**AGENDA  
CITY OF CEDAR FALLS, IOWA  
PLANNING AND ZONING COMMISSION MEETING  
WEDNESDAY, JANUARY 27, 2021  
5:30 PM AT CITY HALL VIA VIDEO CONFERENCE**

- 2. **College Hill Neighborhood Overlay Review (Case #DR20-008)**  
**Location:** 704-706 W. 28th Street  
**Applicant:** Wes Geisler  
**Previous discussion:** No  
**Recommendation:** *Recommend Denial*  
**P&Z Action:** *Review and make a recommendation to Council*

**TO:** Planning and Zoning Commission  
**FROM:** Chris Sevy, Planner I  
**DATE:** January 18, 2021  
**SUBJECT:** Remodel review of property in the College Hill Neighborhood Overlay District

**REQUEST:** Request to approve a College Hill Neighborhood Overlay District floor plan for the addition of bedrooms at 704-706 W 28<sup>th</sup> Street (Project #DR20-008)

Proposed Main Floorplan

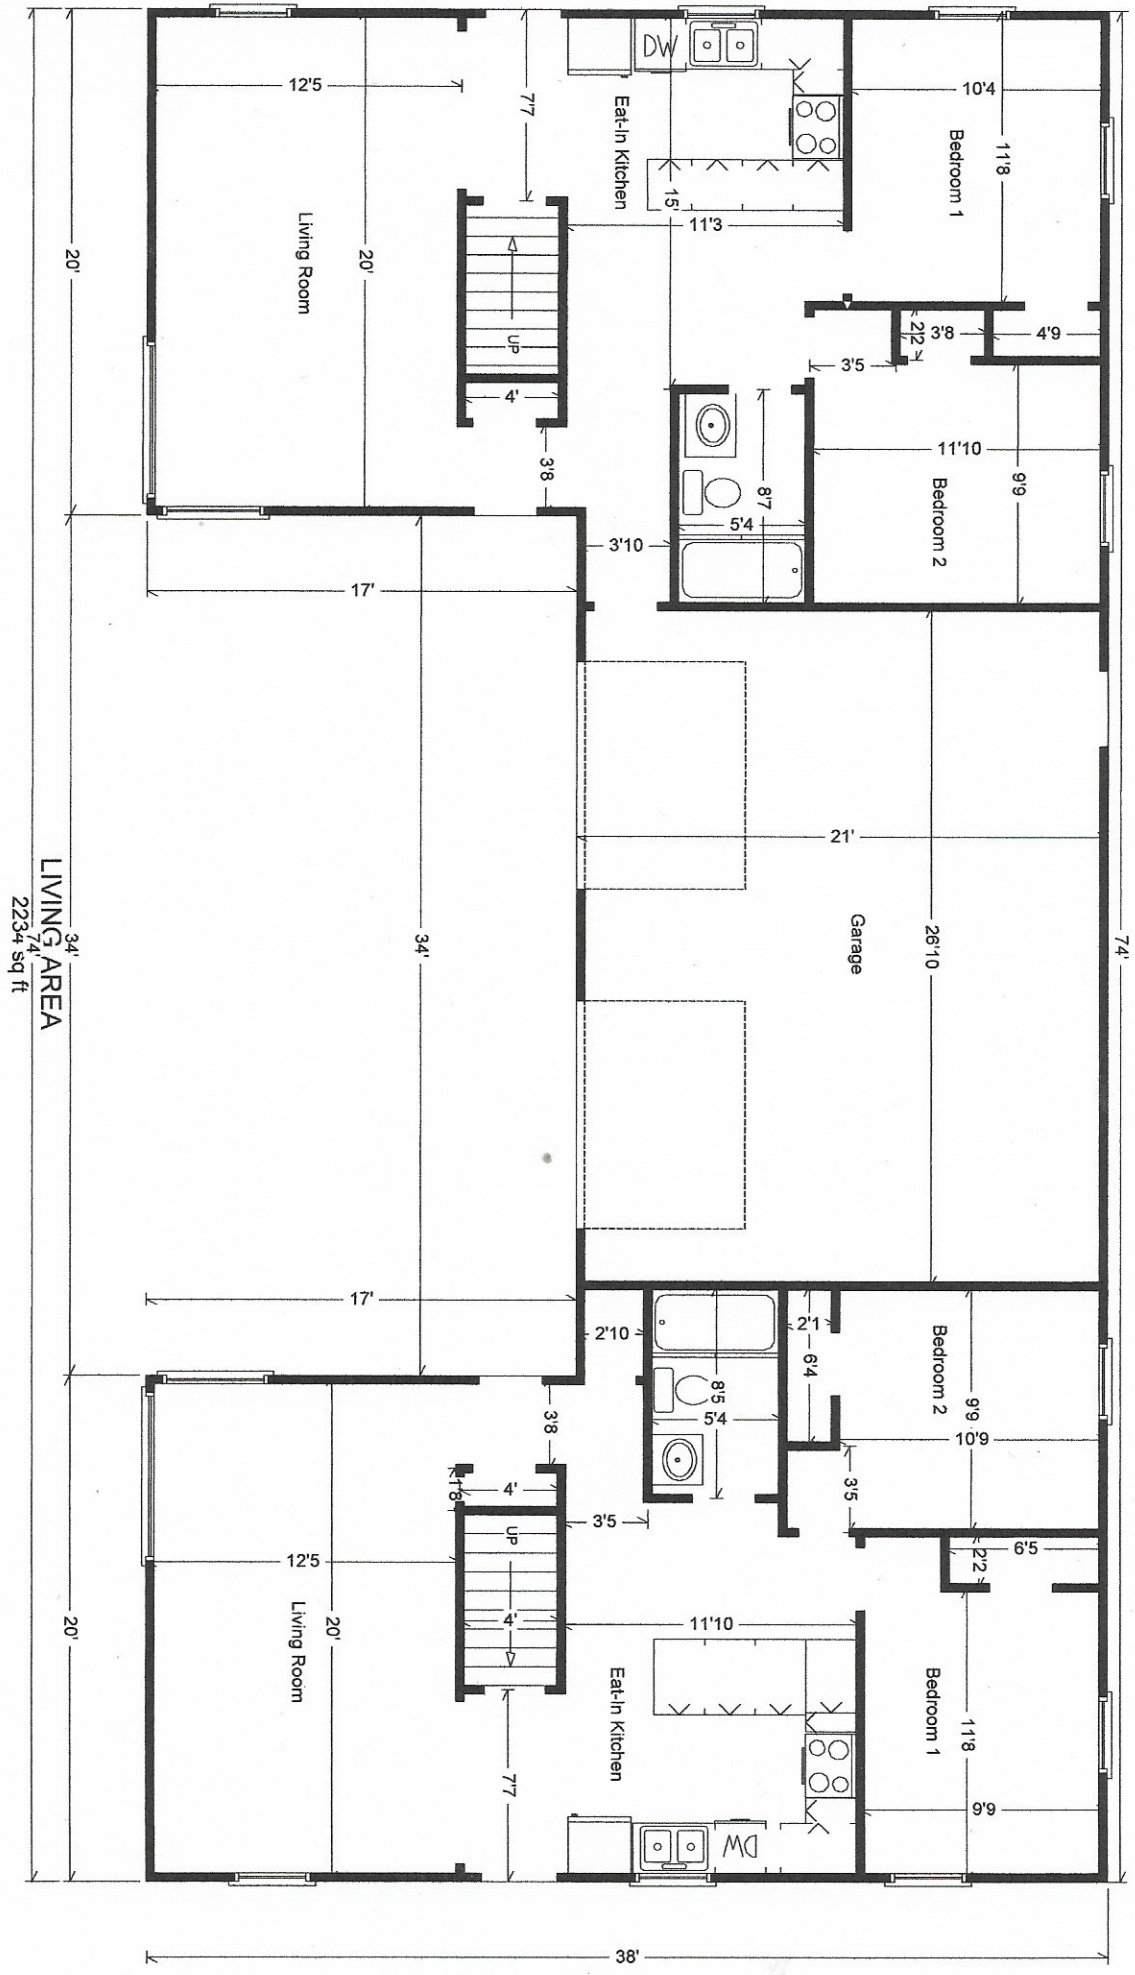
1. Change in density: The properties in the surrounding neighborhood are predominantly rental properties. However, several of the properties within view of this one are owner-occupied. While it is perfectly appropriate for this property to be a rental, doubling the occupancy may not be appropriate given the increased traffic, activity, and changes in neighborhood character that would result.

The disposition of the Technical Review Committee was that the original design and carrying capacity of the property was not intended to serve 8 persons aged 18 years or older. The original building was constructed as a one-story ranch-style duplex. Each dwelling unit contains two modest-sized bedrooms, one bathroom, a small kitchen and modest sized living room. The garage spaces are recessed from the front façade with one garage space for each unit and room for one car parked behind that space in the driveway, so as originally designed the dwelling provided two parking spaces per unit to match the number of bedrooms in each unit. The building is situated so that each unit had usable outdoor space accessed from a side door out to a small patio space. Until recently, each of these outdoor patios was screened by mature shrubbery to provide a semi-private outdoor space for each unit. At 760 square feet of finished space each dwelling unit as it currently exists is a modest space for two adults or a small family to

The additional finished space in the basement, as proposed by the applicant, can certainly accommodate more people. However, this review is not necessarily to consider the appropriateness of the internal changes but to consider the external effects. Preserving neighborhood character is a priority of the College Hill Neighborhood Overlay District. Staff finds that the addition of bedrooms and associated increase in residential occupancy may have a negative effect on this particular neighborhood's character for a number of reasons. Doubling the residential occupancy of this property will result in an increase in the number of cars parked on the property, associated traffic from those cars and visitors, increased parking accommodations causing the loss of mature trees and usable outdoor space, and wear and tear of higher occupancy on this modest-sized property.

There was concern by CFU about the placement of egress windows too close to the gas meters outside; a 3 foot setback was requested. The applicant has indicated that this setback will be maintained.

To preserve neighborhood character and maintain consistency with the original carrying capacity of this dwelling as appropriate to its context, staff recommends that the request to add bedrooms to the building be denied. If approved, staff recommends that approval be subject to the following condition:

- All the following maintenance and potential code compliance items must be included in the renovation:
  - Clean face of gutters
  - Touch up paint as needed at windows
  - Repair/replace rear siding
  - Stairs at the rear door to be replaced
